NATIONAL CAPITAL DEVELOPMENT COMMISSION

REPORT ON
SIR WILLIAM HOLFORD'S
OBSERVATIONS ON THE FUTURE
DEVELOPMENT OF CANBERRA, A.C.T.

30th JUNE, 1958

OBSERVATIONS ON THE FUTURE
DEVELOPMENT OF CANBERRA,
A.C.T.

SECTION THROUGH THE GOVERNMENT TRIANGLE

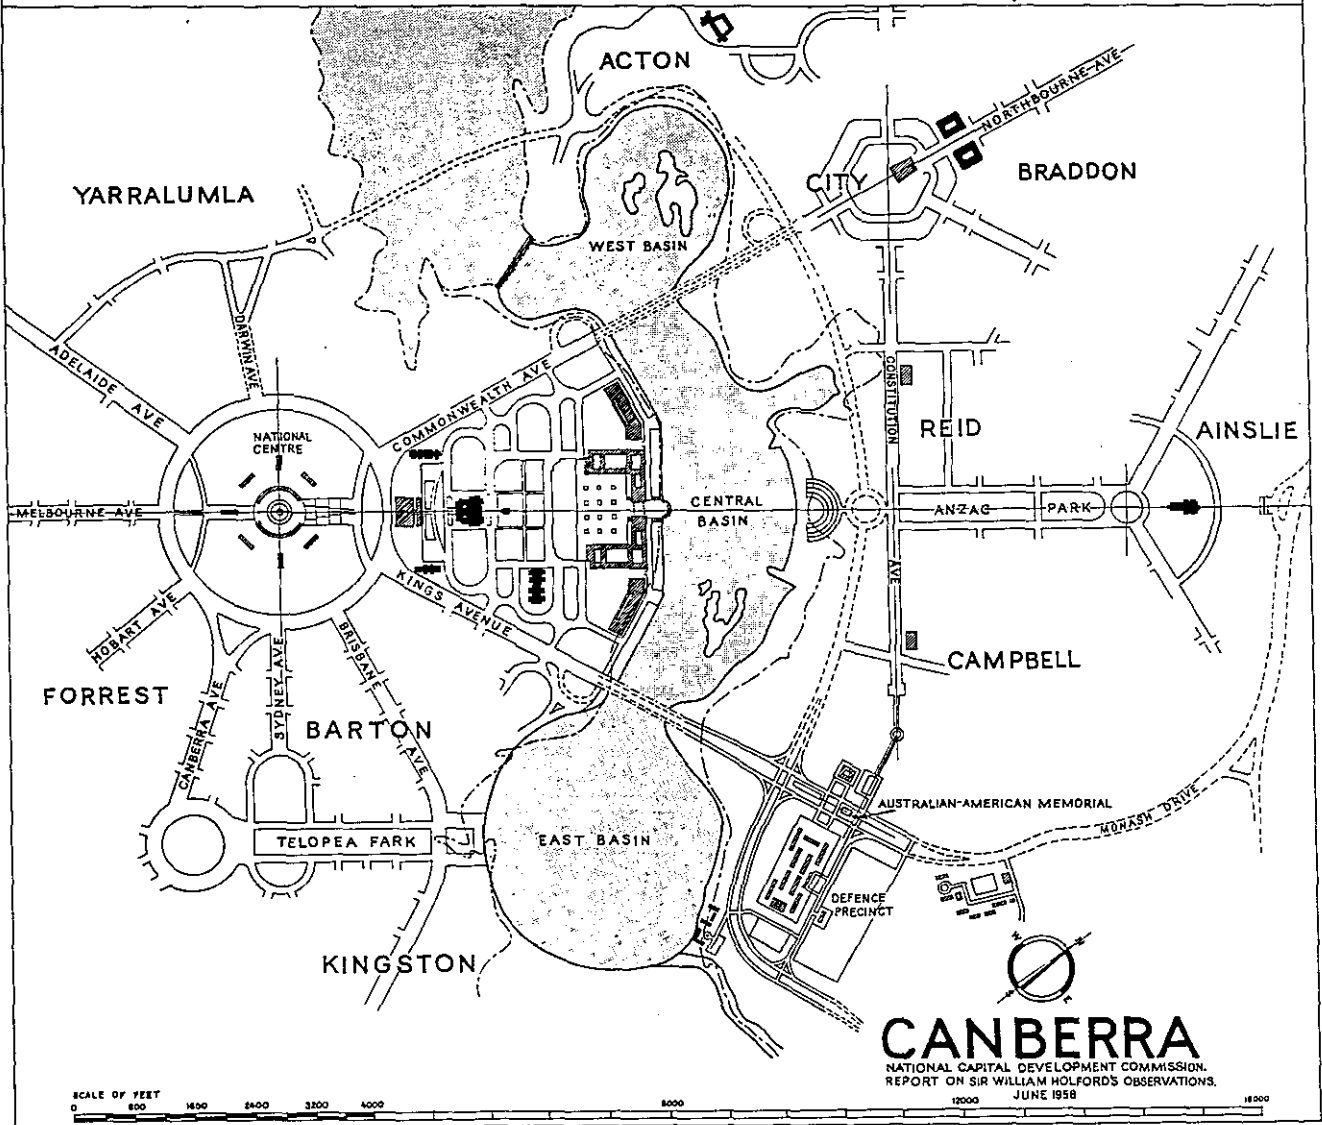
7. Of all the buildings which should be located in this area, by far the most significant is Parliament House itself and we strongly endorse Holford's proposal that it would best be sited on the north side of the Parliamentary Triangle with a second frontage to the central basin of the proposed Lake. This site would give an excellent opportunity for the construction of what might well become one of the world's most distinguished modern buildings. The location of Parliament House in this key position within the Triangle, where it will have the place of honour, will have the following advantages

- (a) It would permanently establish Parliament as the heart of the Government precinct, with the necessary administrative buildings and secretariats grouped around it.
- (b) The site is the only suitable one in the Parliamentary Triangle unless the present Parliament House were demolished. The retention of the present Parliament House for other purposes would ensure that the precinct would soon take shape as an architectural and functional unit.
- (c) The site is easily accessible to traffic and its association with the Lakes enhances its aspect from most parts of the city.
- (d) It would be a major contribution towards achieving a proper visual relationship between the present Parliament House, the Australian War Memorial and other buildings on the northern side of Canberra and could also bring harmony and coherence to the parliamentary group.

8. We have examined the possibilities of other sites in or near the Triangle, in particular Camp Hill, as originally suggested by Griffin, and Capital Hill, as recommended in the Senate Report. (p. 75, para. 64). We consider the Camp Hill site unsuitable because it is too limited for traffic requirements and because any building on this locality would be obscured by the present Parliament House. A rather misleading impression of the importance of Capital Hill as a building site is given by the paper plan of Canberra and it should be noted that although its visibility is good from the Queanbeyan side, from the Triangle it cannot be seen at all. Capital Hill therefore seems to us inappropriate for the key building of the Parliamentary group, which would not only be dissociated from both the secretariats and the Lakeside but would also be almost invisible from the central areas of the city.

DIAGRAM to illustrate OBSERVATIONS on the FUTURE OF CANBERRA

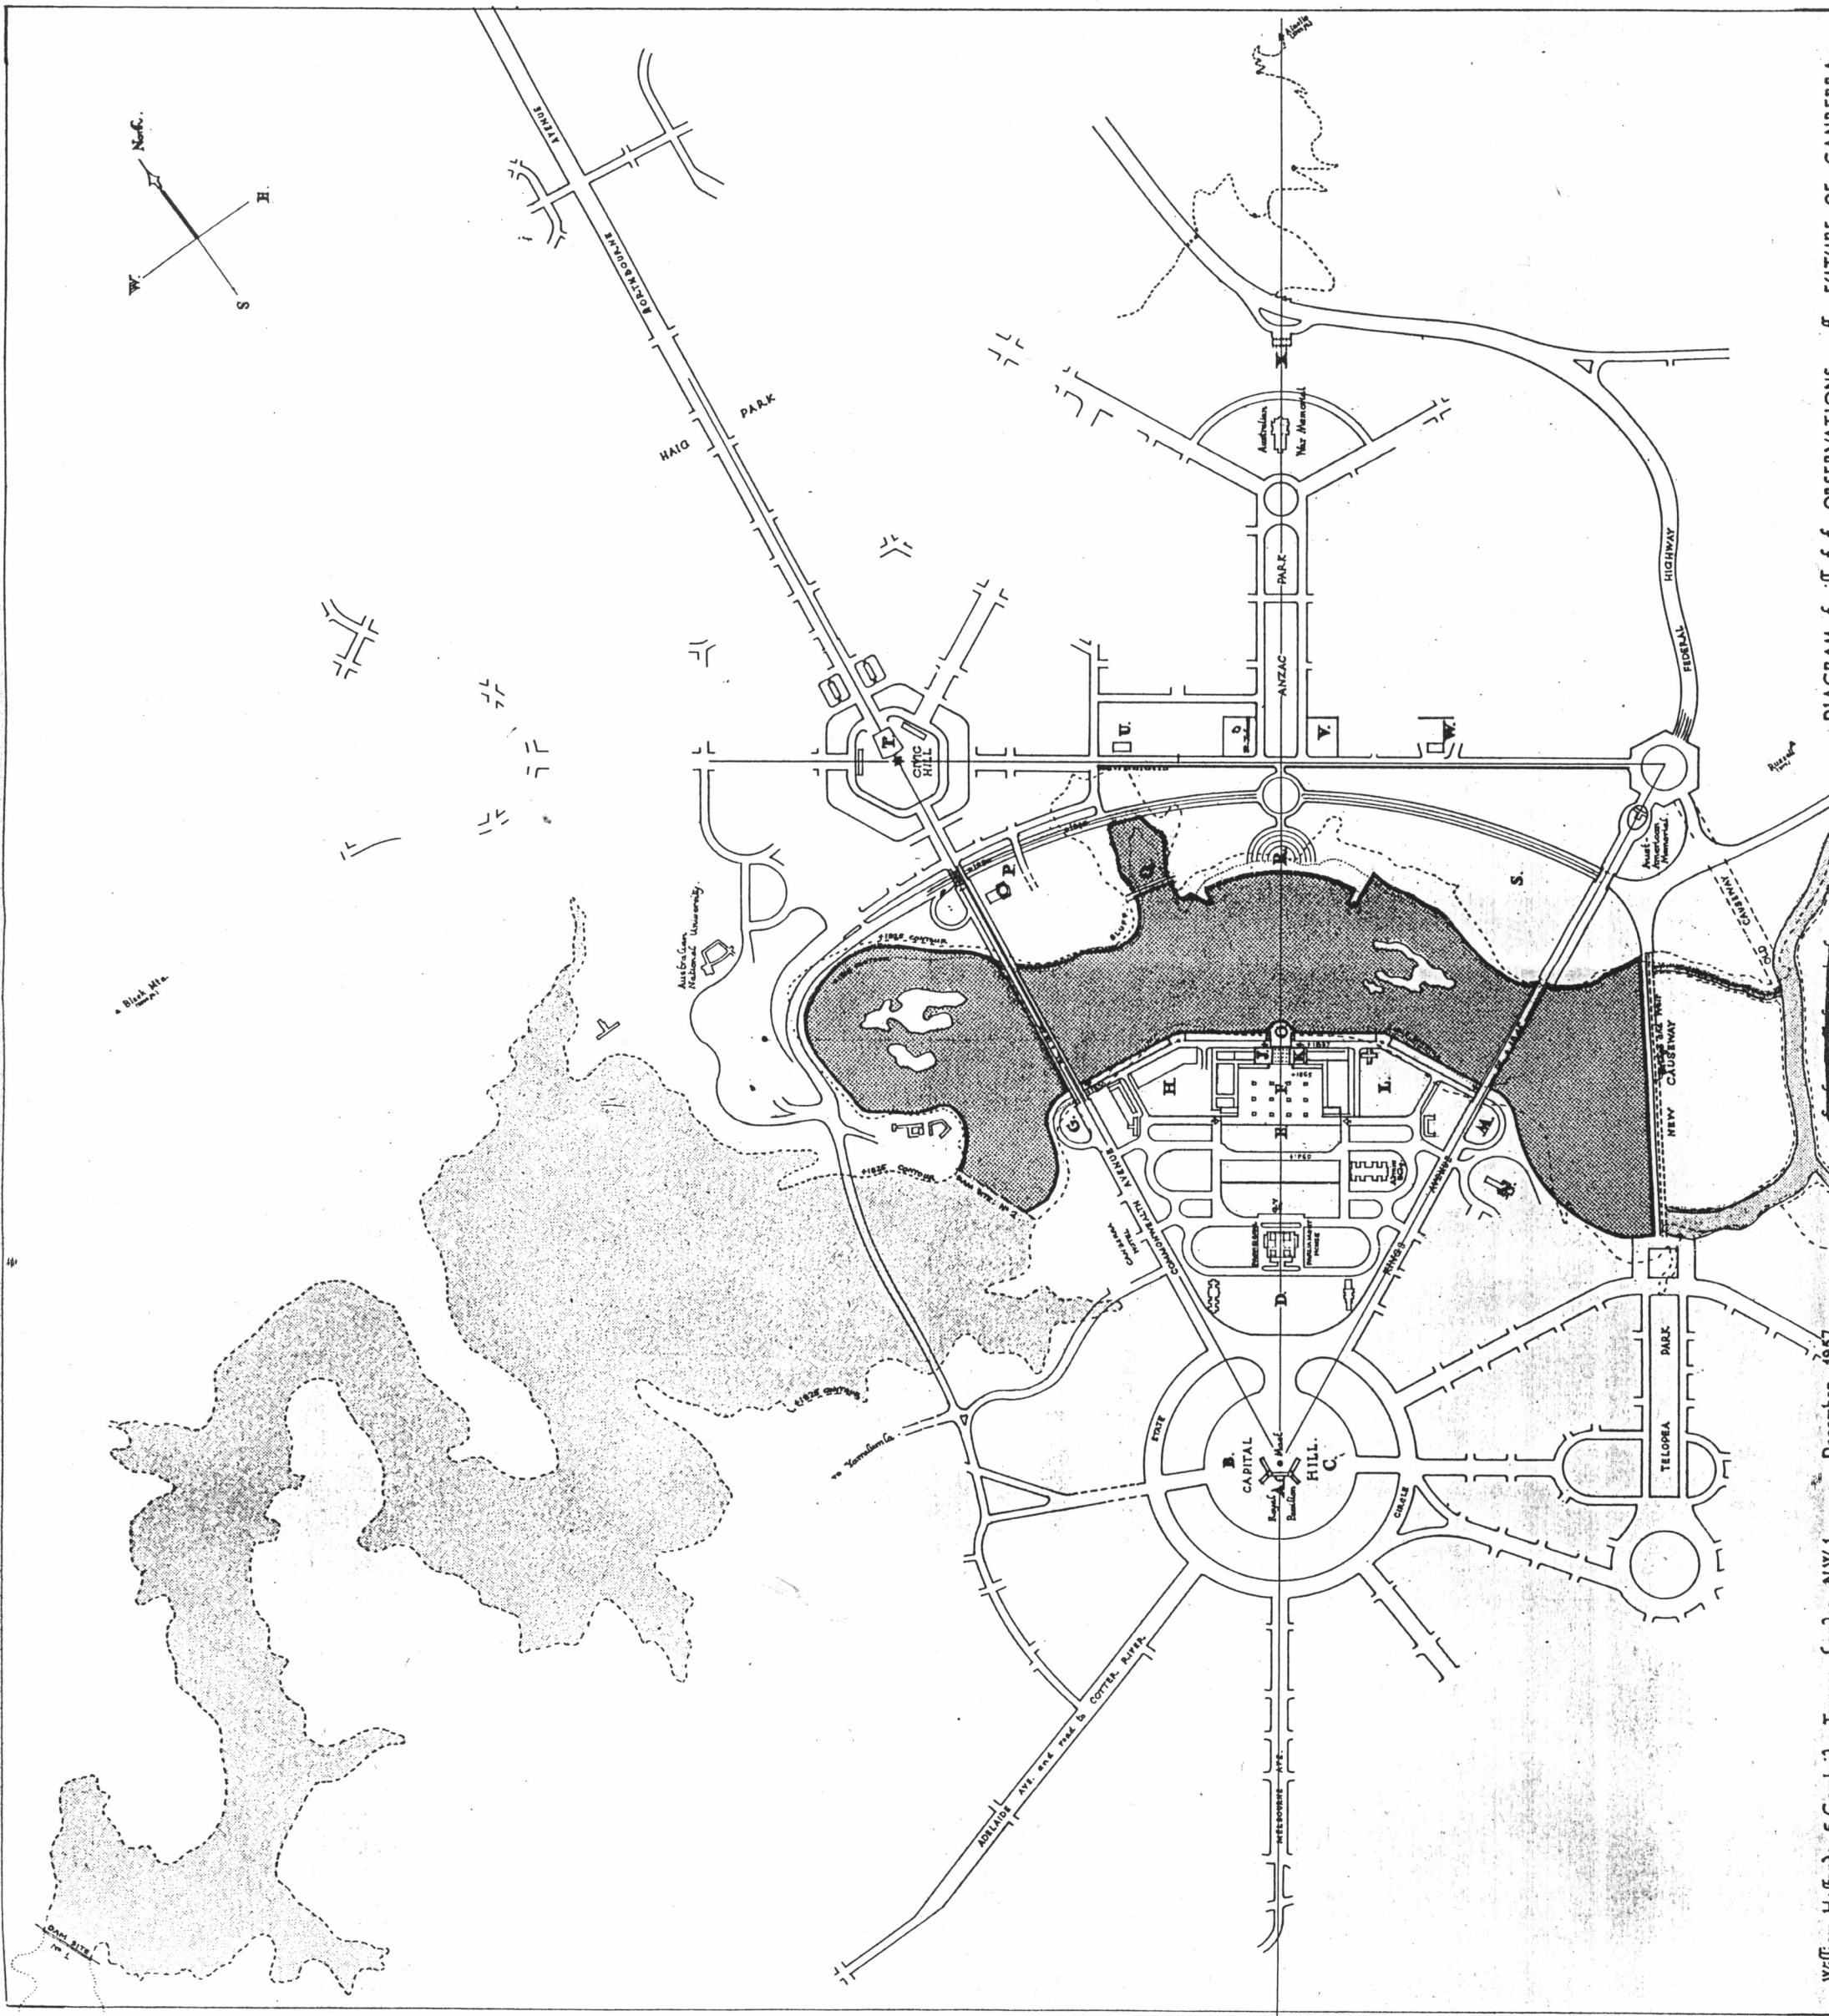
- (5) The West Basin, as shown on the diagram which accompanies these observations, would be slightly less extensive than that shown on the Gazetted plan, and would have a mounded island in the centre made up on the basis of equalizing cut and fill.
- (6) The East Basin, which—if my suggestion is followed—would be bisected by a new Causeway, would either be flooded as shown on the Gazetted plan, or held by a barrage underneath the bridge, leaving the natural courses of the river above the bridge to be banked to a level of about +1830. This would be cheaper than filling the whole basin to get above flood level; and would still permit more or less permanent grazing, or recreational use, or both together, in the reclaimed area.

In order to show how the various suggestions I have made would hang together in their application to the existing plan of Canberra, and appear as variations to the Gazetted Plan, I have attached a Diagram showing the approximate route of the internal link road or parkway, the contour of the lakes, and the approximate location of certain features. On this Diagram I have lettered certain sites A.-X.; and it might be helpful if I included at this stage an annotated list of references to them and some of their associated problems.

- F. *The Forecourt*.—Mostly paved, but with some planting; about 1,000 feet by 600 feet.
- G. *Loop*.—Connecting one carriageway of Commonwealth-avenue with the northern access road to Parliament House. NOTE.—The other carriageway connects via the approach road on the west side of H.
